## PUBLIC HEARING / WORKING SESSION MEMORANDUM

### PETITION #33-21 (3)

275 Grove Street

## Responses to Questions Posed at October 5, 2021 Land Use Committee Meeting

Figure 3.6B  
2021 Existing Conditions  
Weekday Morning Peak Hour Traffic Volumes

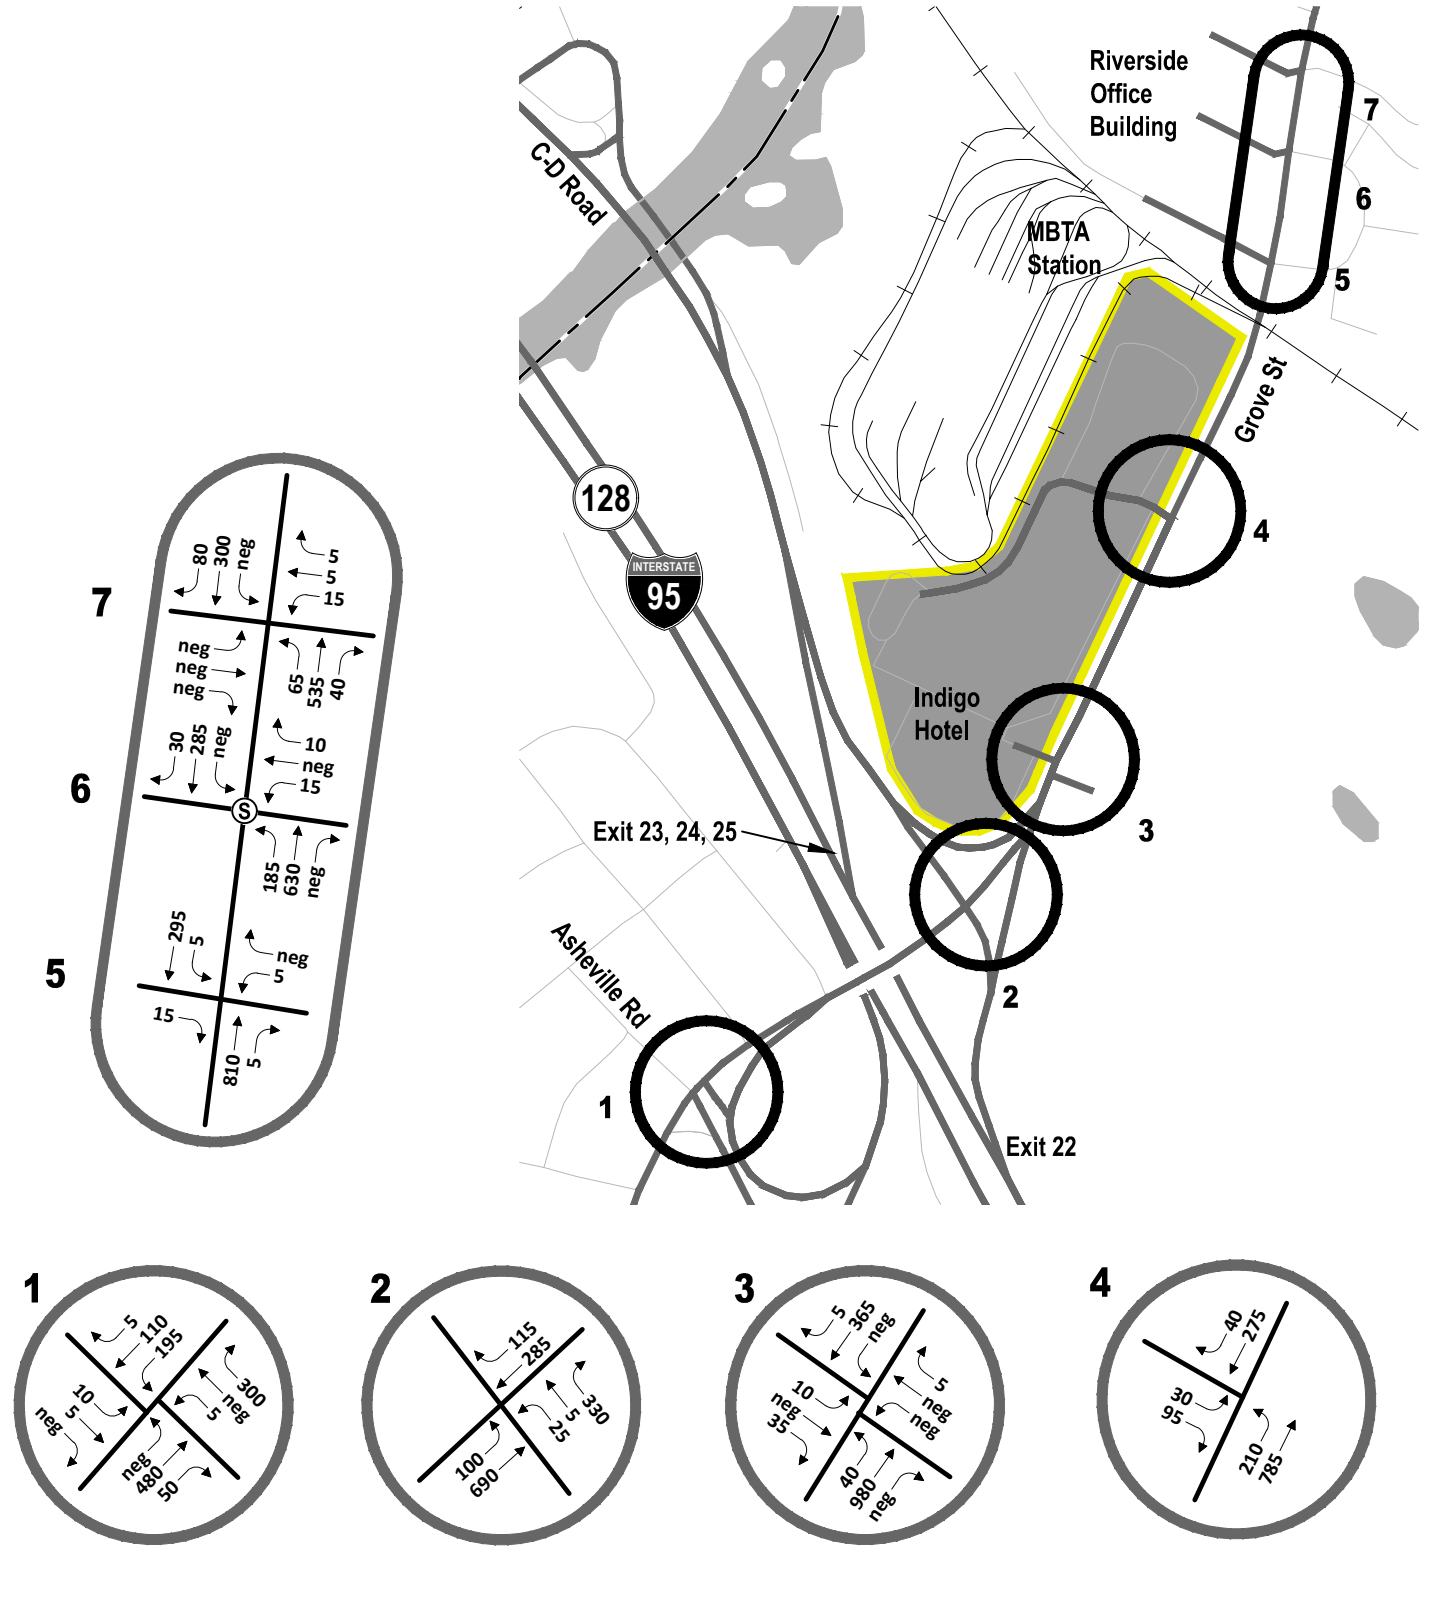
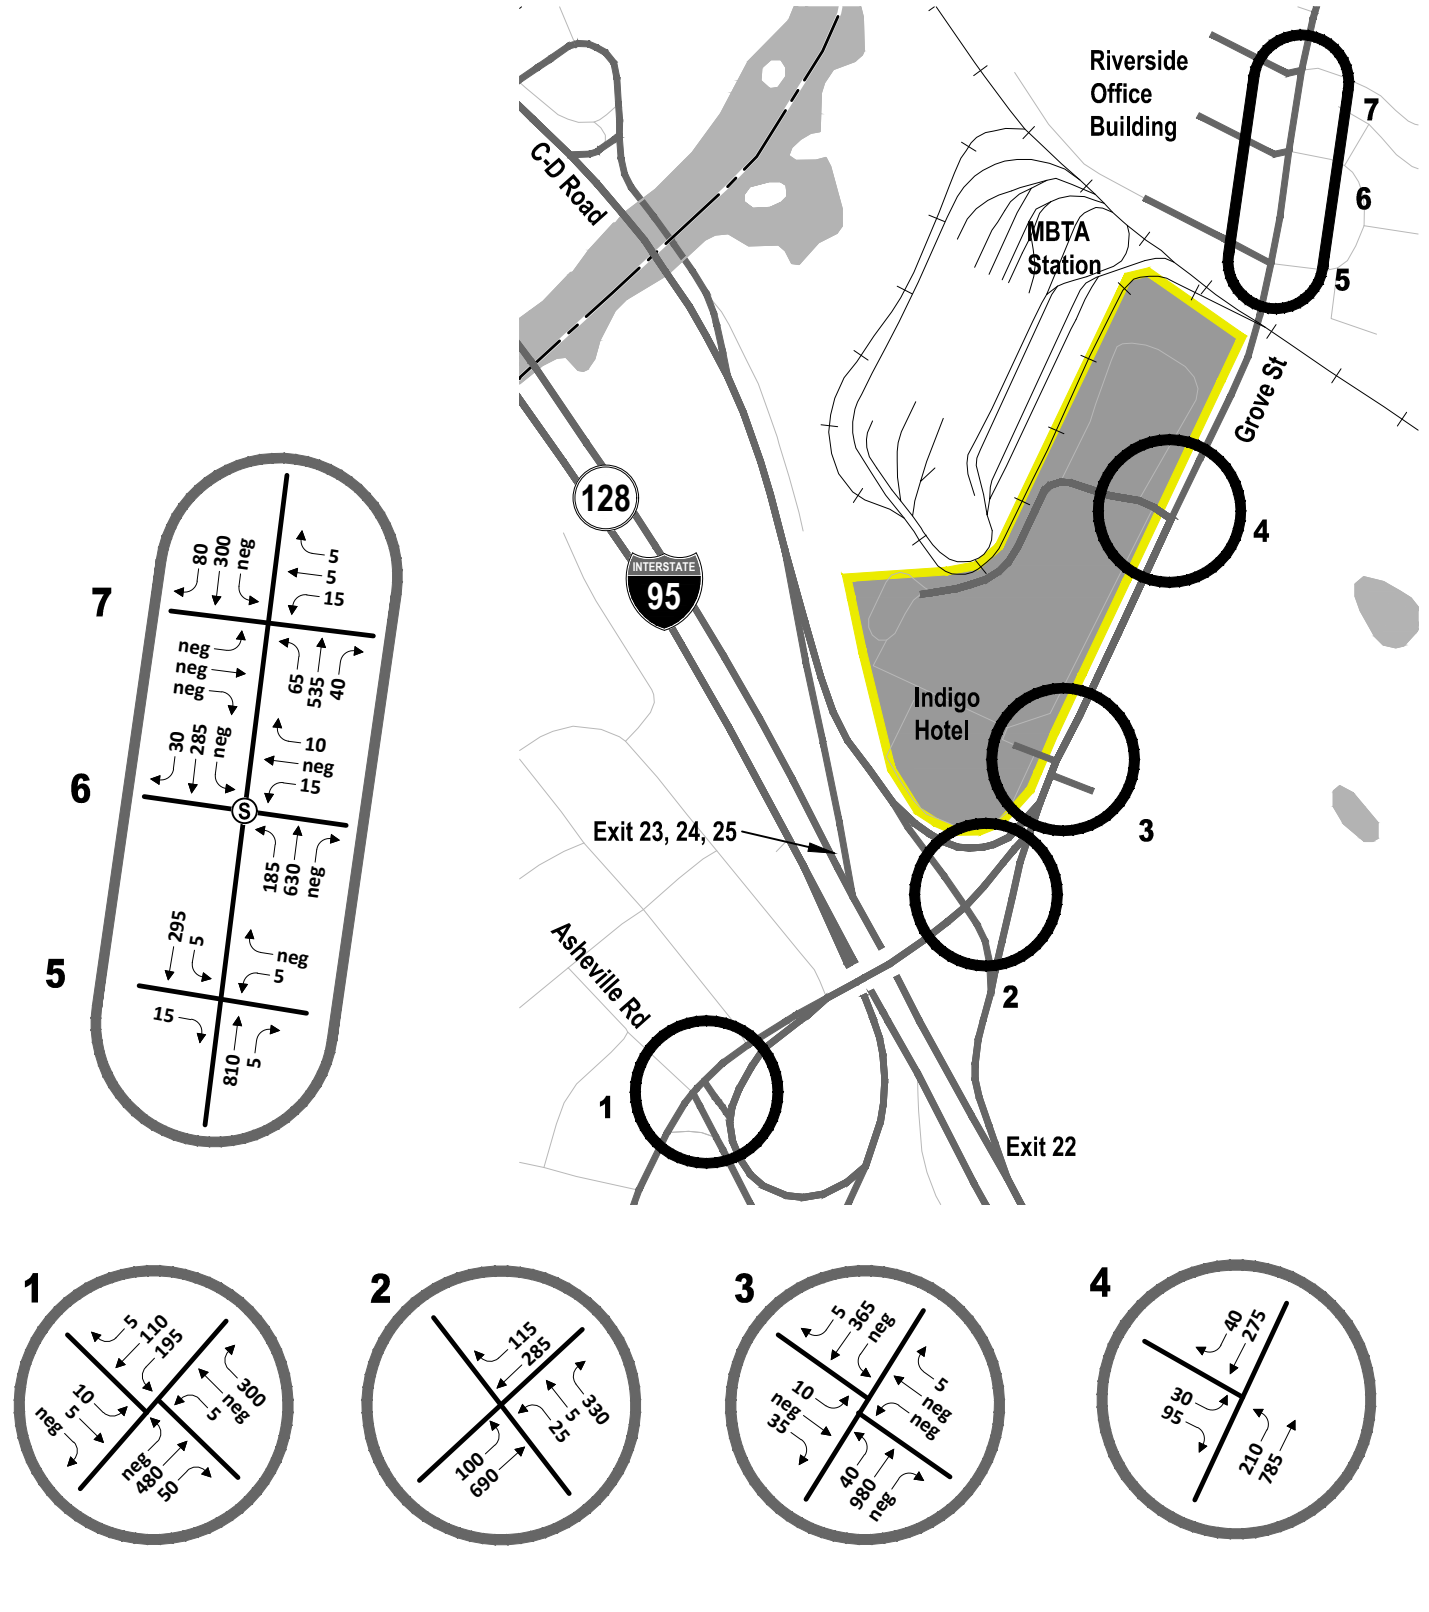
As noted in Neil's Email, the Williams School starts morning drop offs and bus operations between 8:10-8:20 AM, which is right in the middle of the Grove Street weekday morning peak hour (7:45-8:45 AM). With that in mind, a reduction in traffic associated with the conversion of general office to R&D during the weekday morning peak hour is a benefit of the project. To assess the "change" in 275 Riverside Office Park (275 ROP) traffic along Grove Street at the Williams School during this period, existing condition traffic volumes from the Riverside Redevelopment and projections for the R&D use of building 3 were utilized. From the data provided in the Riverside TIA during the weekday morning peak hour:

As noted in Neil's Email, the Williams School starts morning drop offs and bus operations between 8:10-8:20 AM, which is right in the middle of the Grove Street weekday morning peak hour (7:45-8:45 AM). With that in mind, a reduction in traffic associated with the conversion of general office to R&D during the weekday morning peak hour is a benefit of the project. To assess the "change" in 275 Riverside Office Park (275 ROP) traffic along Grove Street at the Williams School during this period, existing condition traffic volumes from the Riverside Redevelopment and projections for the R&D use of building 3 were utilized. From the data provided in the Riverside TIA during the weekday morning peak hour:

With the change proposed to building 3, there will be approximately 16 less trips during the weekday morning peak hour that pass the Williams School. A reduction of 16 trips from the existing conditions means that with the proposed change, approximately 94 total trips generated by 275 ROP are expected to pass by the Williams School during the weekday morning peak hour.

With the change proposed to building 3, there will be approximately 16 less trips during the weekday morning peak hour that pass the Williams School. A reduction of 16 trips from the existing conditions means that with the proposed change, approximately 94 total trips generated by 275 ROP are expected to pass by the Williams School during the weekday morning peak hour.

Figure 3.7B  
2021 Existing Conditions  
Weekday Evening Peak Hour Traffic Volumes

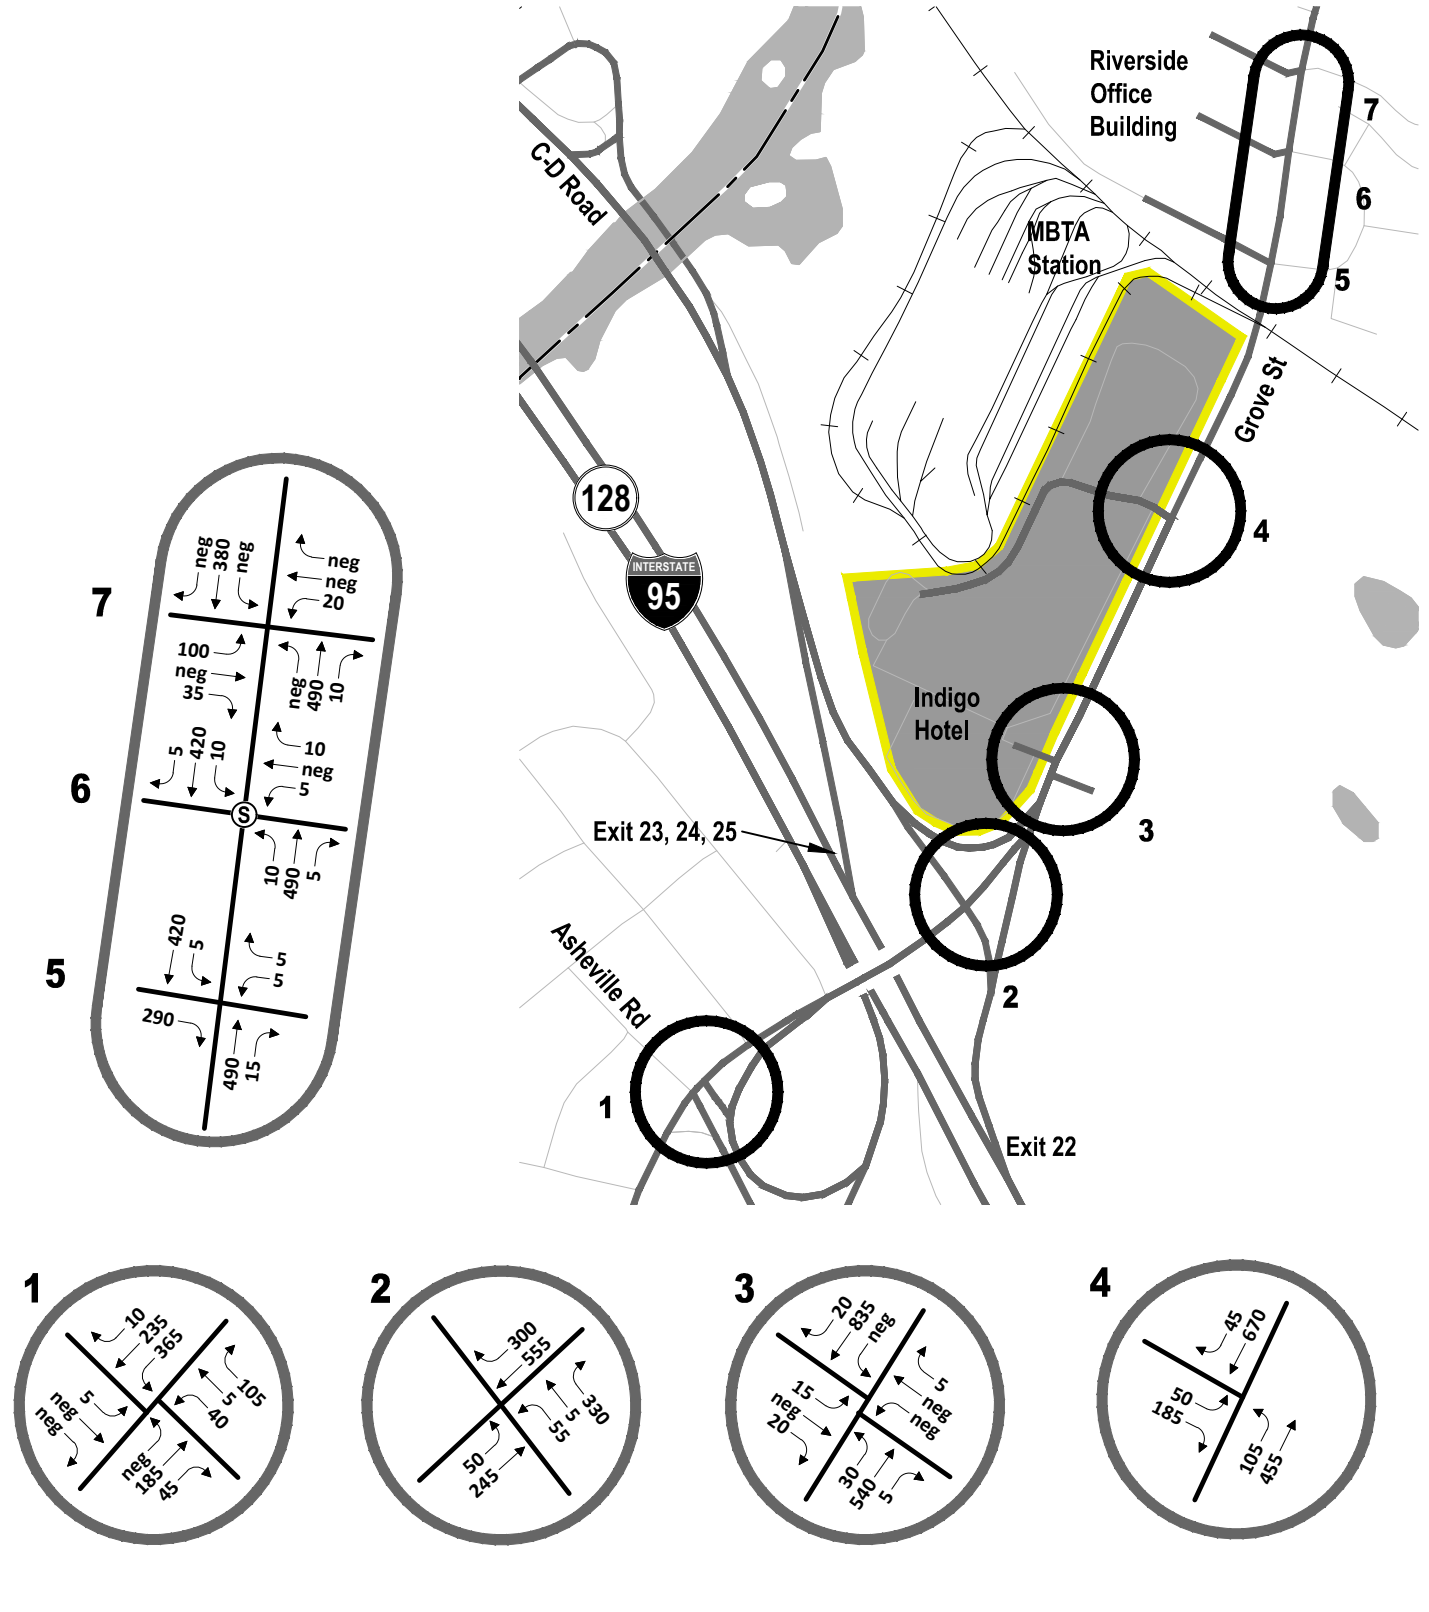
As noted in Neil's Email, the Williams School starts afternoon pick-up and bus operations between 2:50-3:10 PM which is well outside of the Grove Street weekday afternoon peak hour (4:45-5:45 PM). To assess the "change" in 275 Riverside Office Park (275 ROP) traffic along Grove Street at the Williams School during this period, existing condition traffic volumes from the Riverside Redevelopment and projections for the R&D use of building 3 were utilized. From the data provided in the Riverside TIA, during the weekday evening peak hour:

As noted in Neil's Email, the Williams School starts afternoon pick-up and bus operations between 2:50-3:10 PM which is well outside of the Grove Street weekday afternoon peak hour (4:45-5:45 PM). To assess the "change" in 275 Riverside Office Park (275 ROP) traffic along Grove Street at the Williams School during this period, existing condition traffic volumes from the Riverside Redevelopment and projections for the R&D use of building 3 were utilized. From the data provided in the Riverside TIA, during the weekday evening peak hour:

Using the general office ITE trip distribution, the 4:00-5:00 PM hour is approximately 4.8% higher than the 3:00-4:00 PM hour. Since traffic associated with R&D type facilities have a tendency of arriving and departing earlier than traditional office, to provide a conservative analysis we have assumed that while similar shift in traffic between afternoon and evening hours would occur for R&D facilities, the 4.8% higher volume would occur instead between 2:30-3:30 PM as opposed to the PM Peak hour of the adjacent street (4:45-5:45 PM). If that is the case, the PM peak projections from Table 3 (318 peak hour site-generated trips) would result in approximately 15 additional trips during the 2:30-3:30 PM hour over the peak hour of adjacent street. Assuming the 30% distribution of 275 ROP traffic to the north (existing condition), that suggests there could be an increase of 4 trips per hour over existing conditions during the 2:30-3:30 hour. That change represents approximately one vehicle every 15 minutes.

Using the general office ITE trip distribution, the 4:00-5:00 PM hour is approximately 4.8% higher than the 3:00-4:00 PM hour. Since traffic associated with R&D type facilities have a tendency of arriving and departing earlier than traditional office, to provide a conservative analysis we have assumed that while similar shift in traffic between afternoon and evening hours would occur for R&D facilities, the 4.8% higher volume would occur instead between 2:30-3:30 PM as opposed to the PM Peak hour of the adjacent street (4:45-5:45 PM). If that is the case, the PM peak projections from Table 3 (318 peak hour site-generated trips) would result in approximately 15 additional trips during the 2:30-3:30 PM hour over the peak hour of adjacent street. Assuming the 30% distribution of 275 ROP traffic to the north (existing condition), that suggests there could be an increase of 4 trips per hour over existing conditions during the 2:30-3:30 hour. That change represents approximately one vehicle every 15 minutes.
